Sent: 25/10/2022 10:53:51 AM
Subject: Submission - issues of concern with proposed development at 9 Kananook Avenue BAYVIEW
Attachments: STAMPED_MODIFIED_CONSENT_PLANS_N0199_04_-_KNICOL_PTY_LTD.pdf; First Floor Plan Mark-Up.pdf;

Application No. DA2022/1586

Address: Lot 31 DP 11423 9 Kananook Avenue BAYVIEW

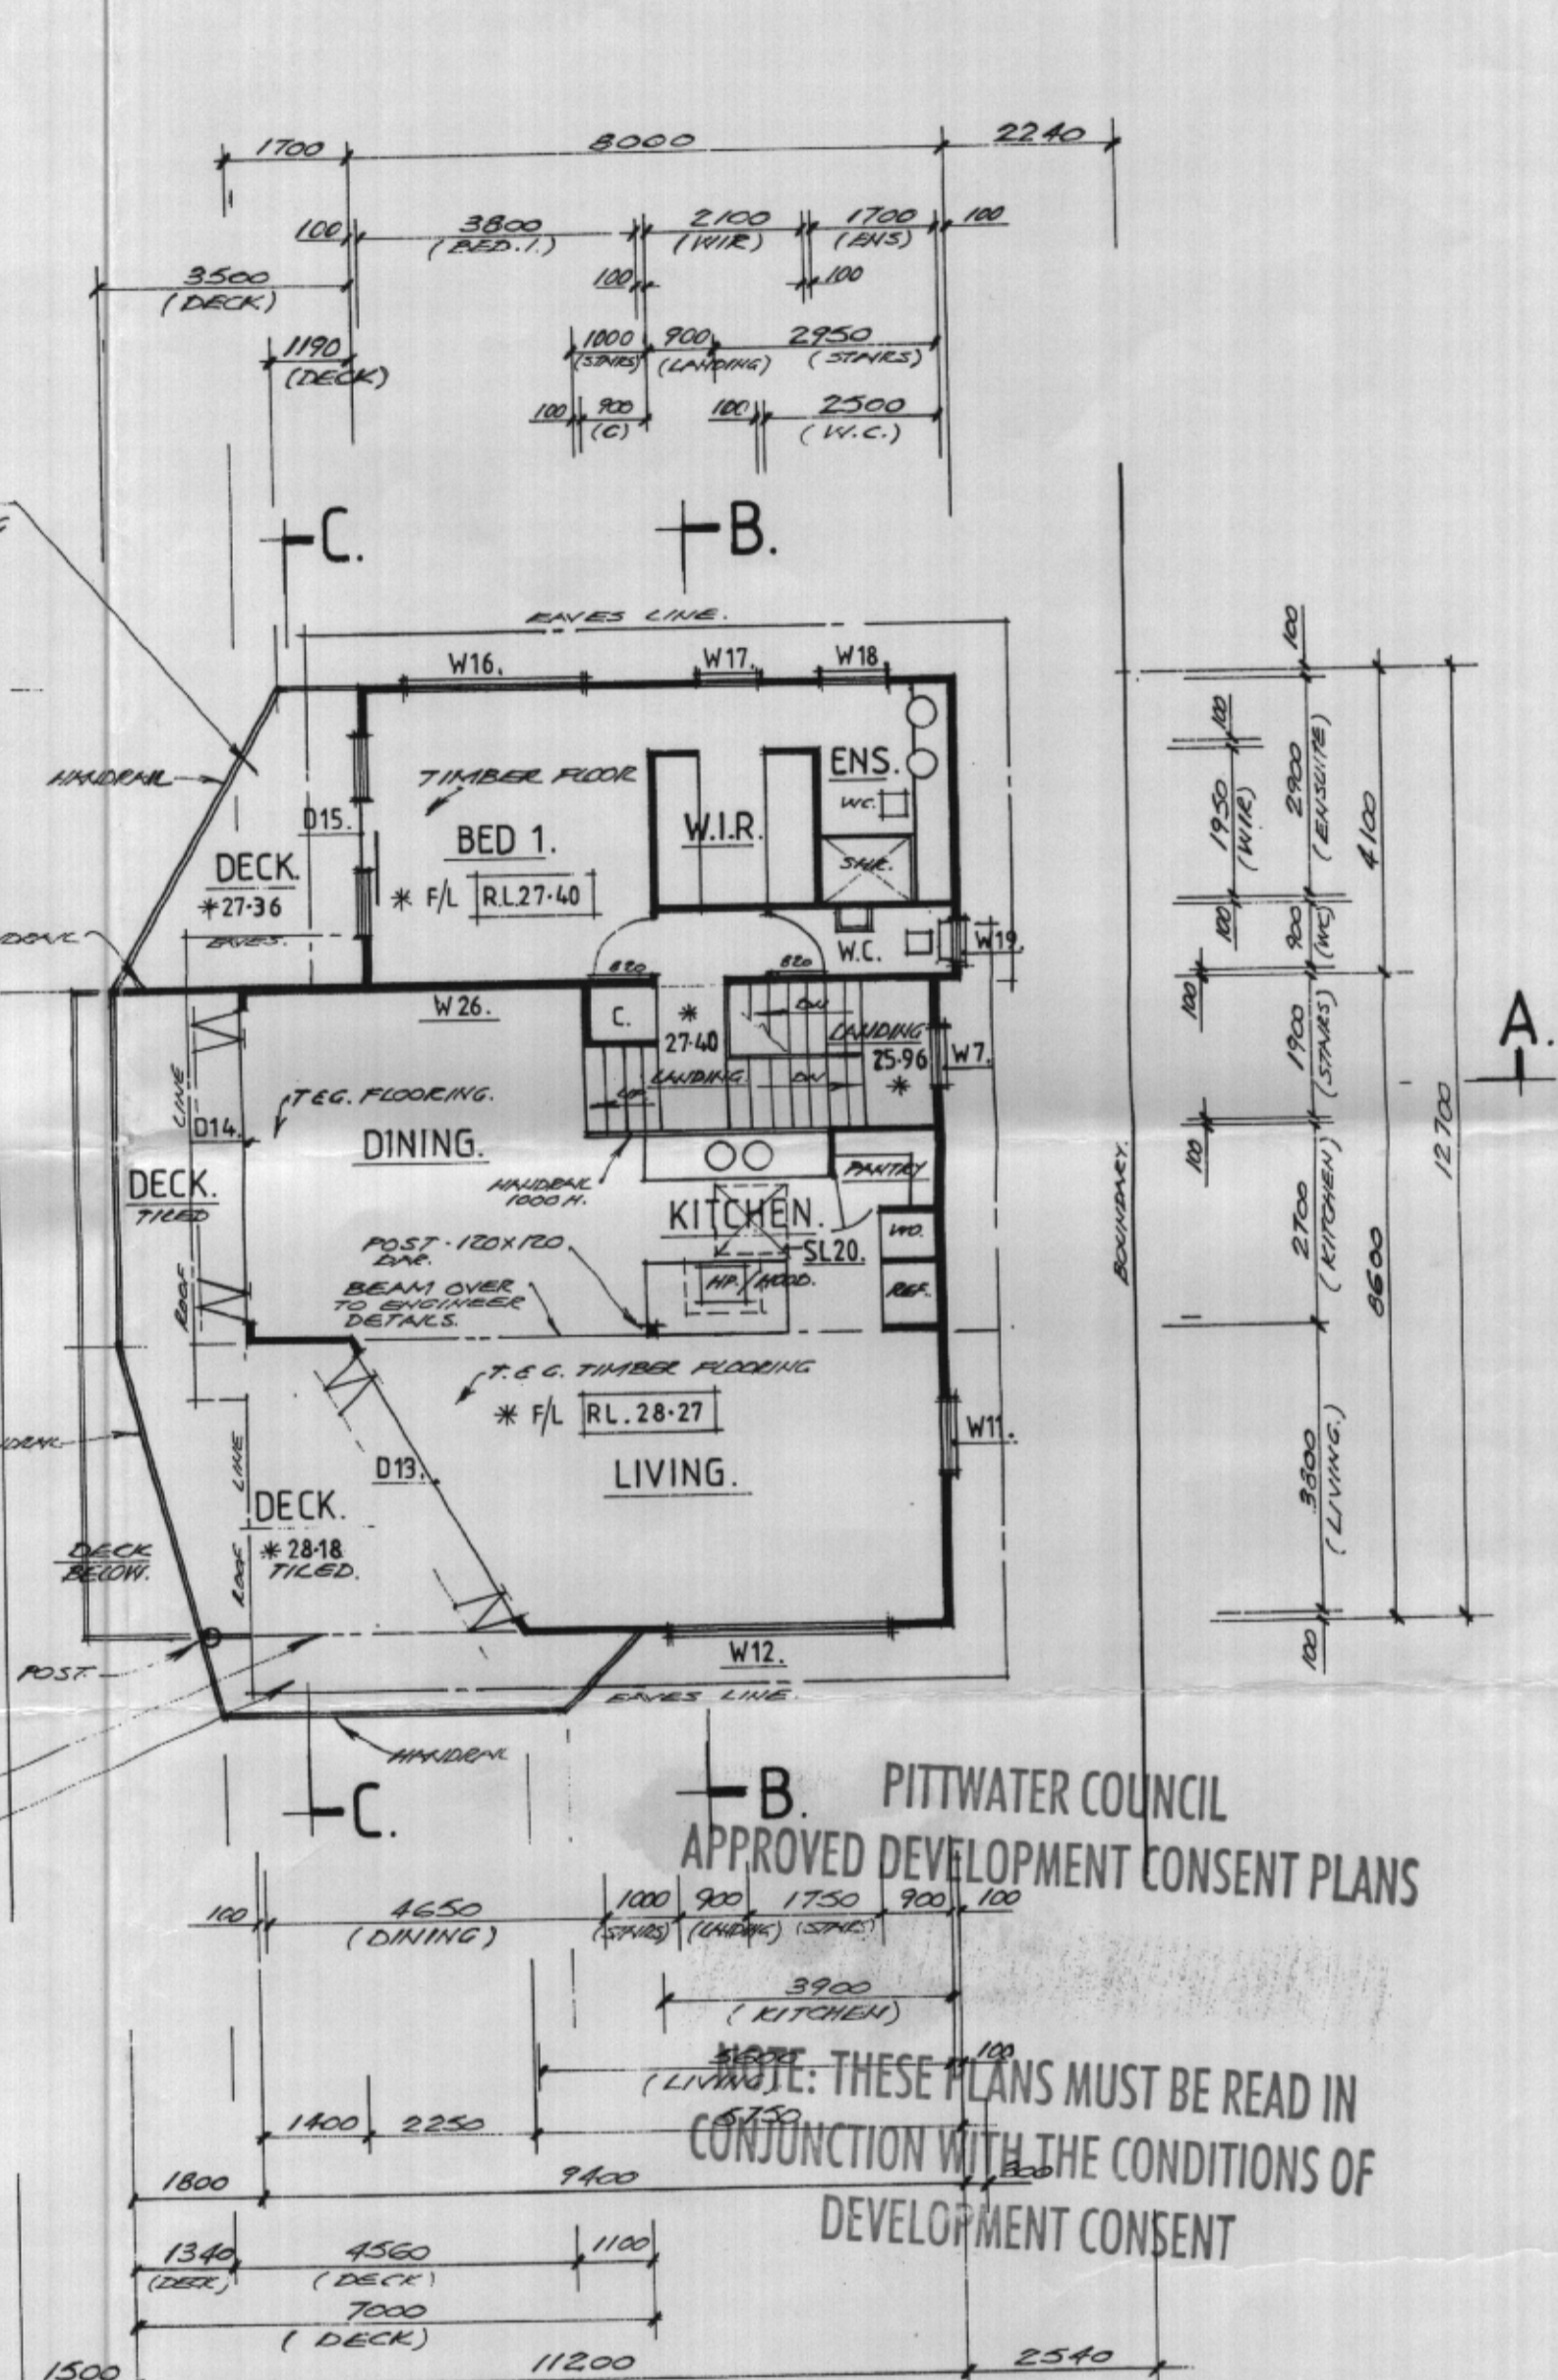
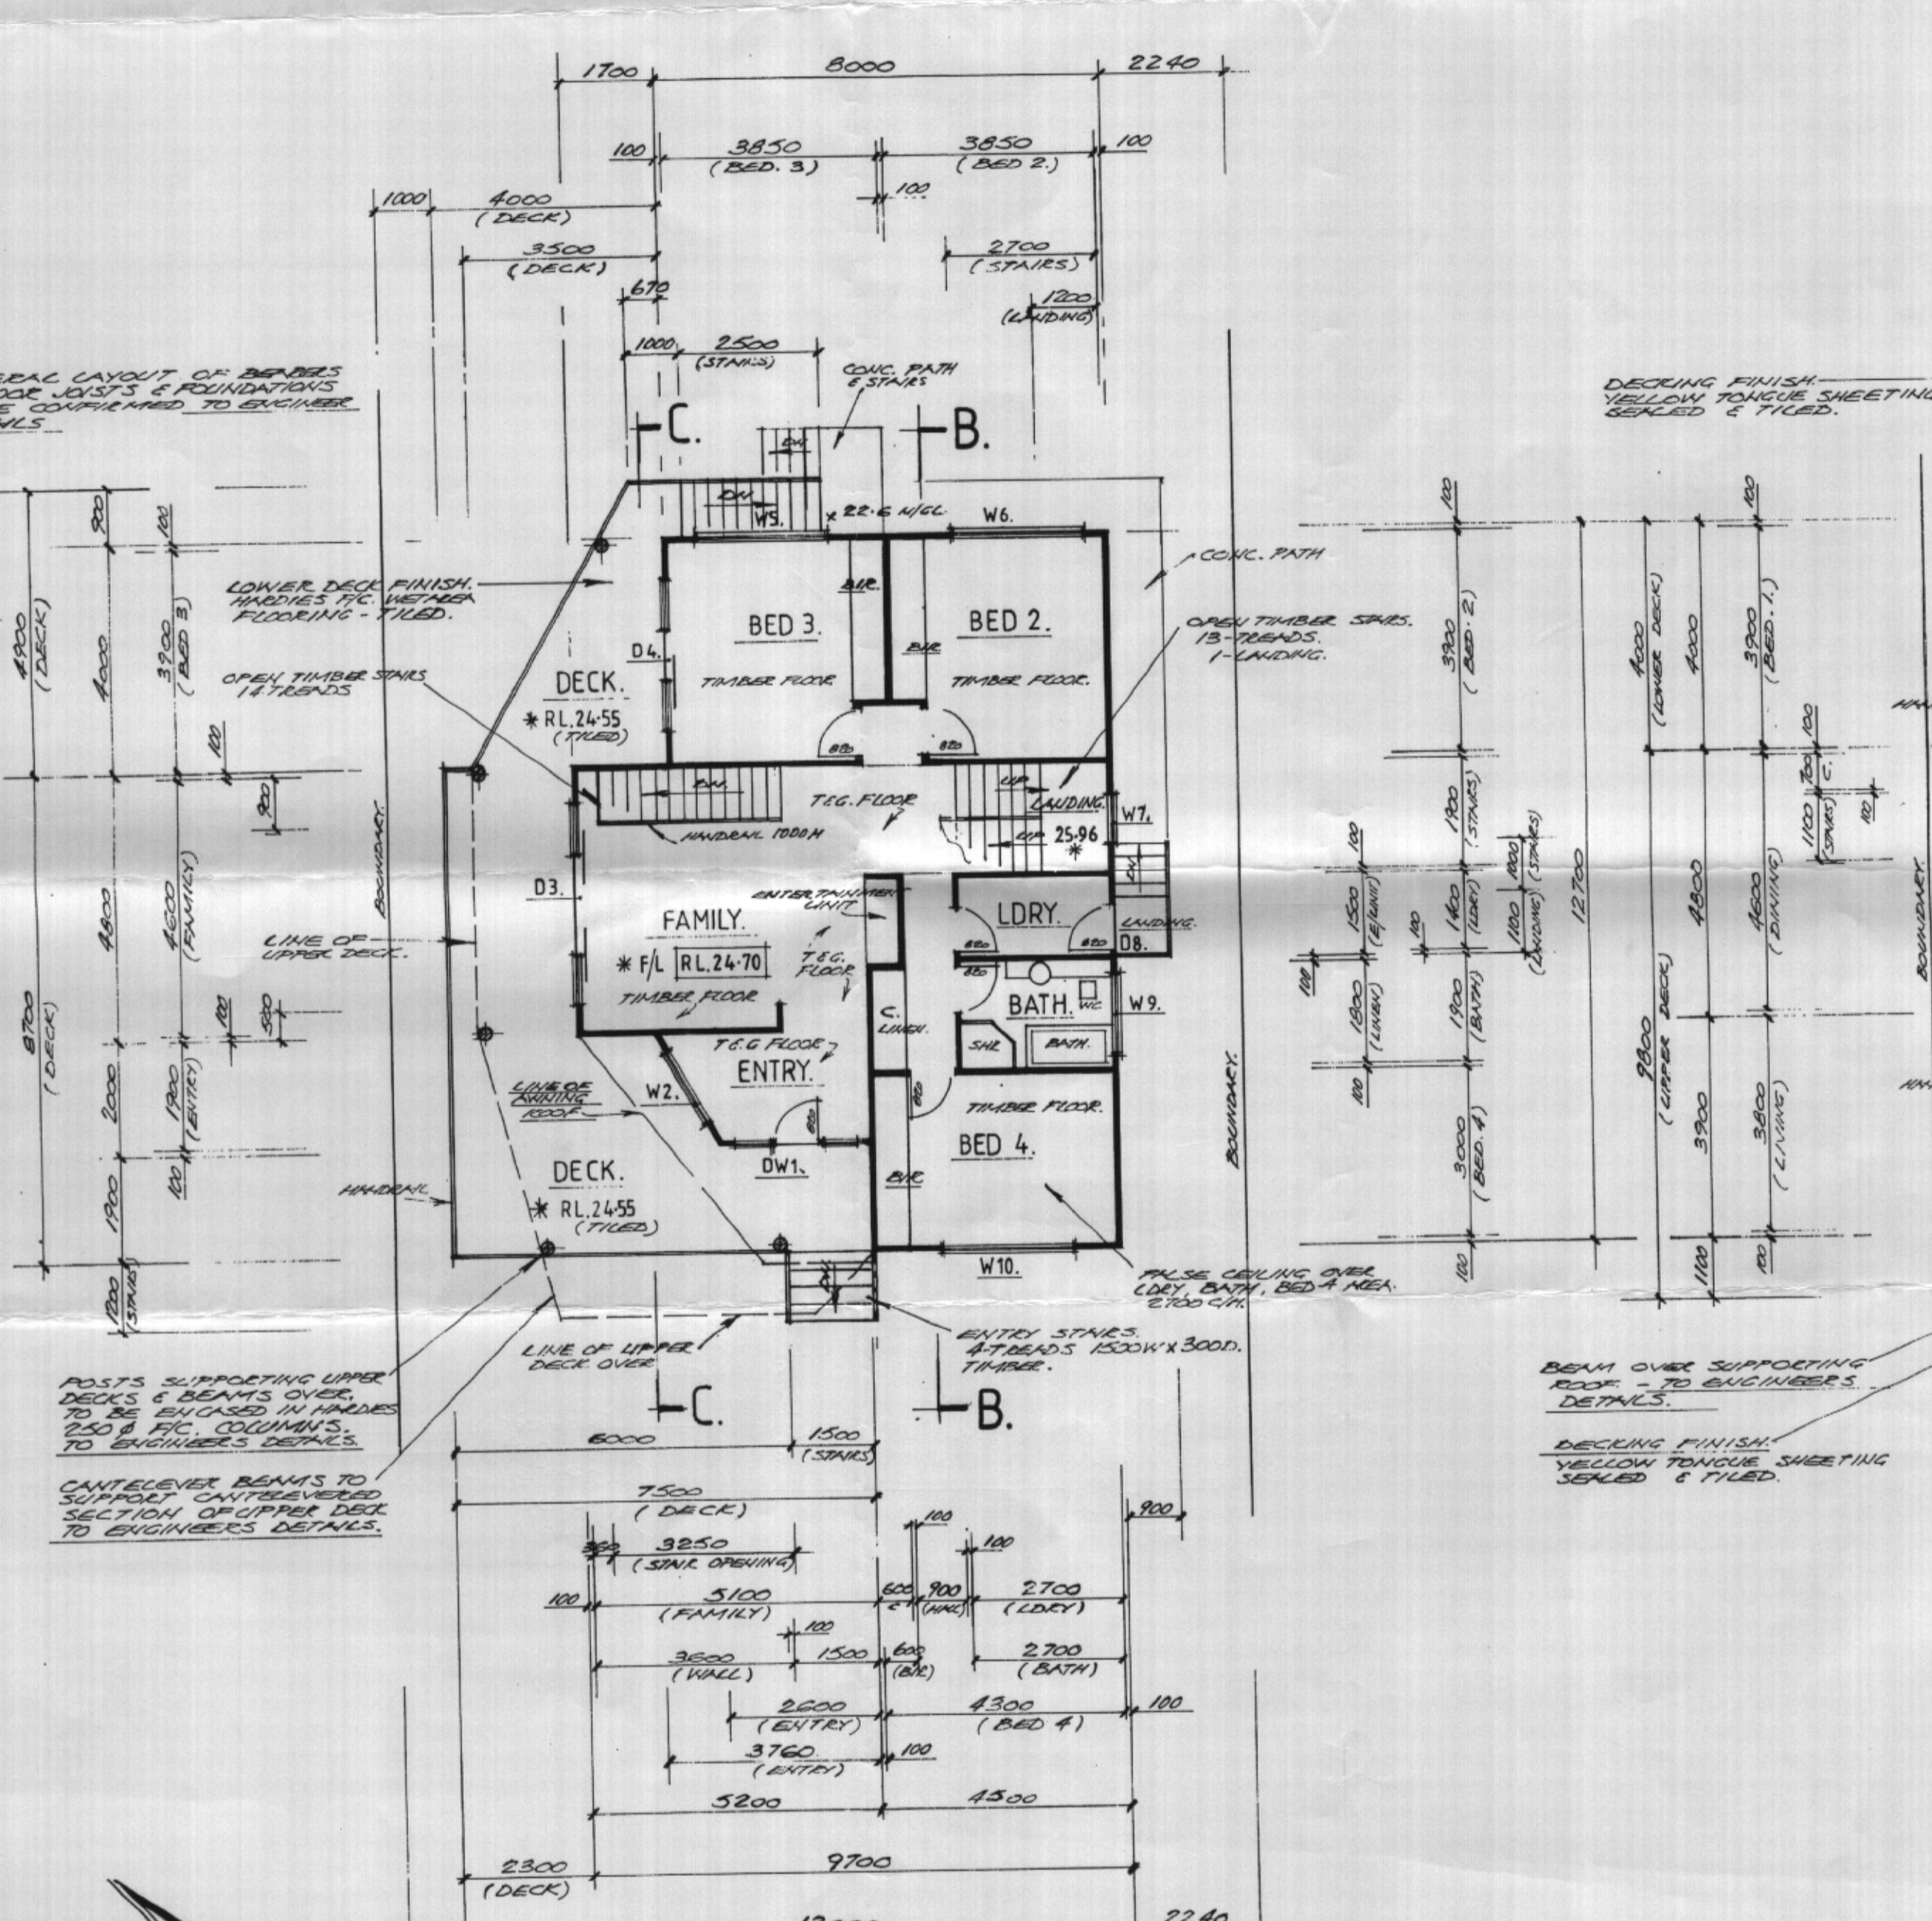
The Existing First Floor Plan and the Demolition First Floor Plan incorrectly identify the footprint of the existing upper floor deck.

As the Proposed First Floor Plan is superimposed on the Survey, the outline of the upper balcony is visible on the plans. The approximate outline of the existing first floor balcony is highlighted in green on the attached marked-up plan, with the area in yellow being the portion of the deck that we believe should be identified as proposed new works. This also translates to the elevations and sections which are also inconsistent in this regard.
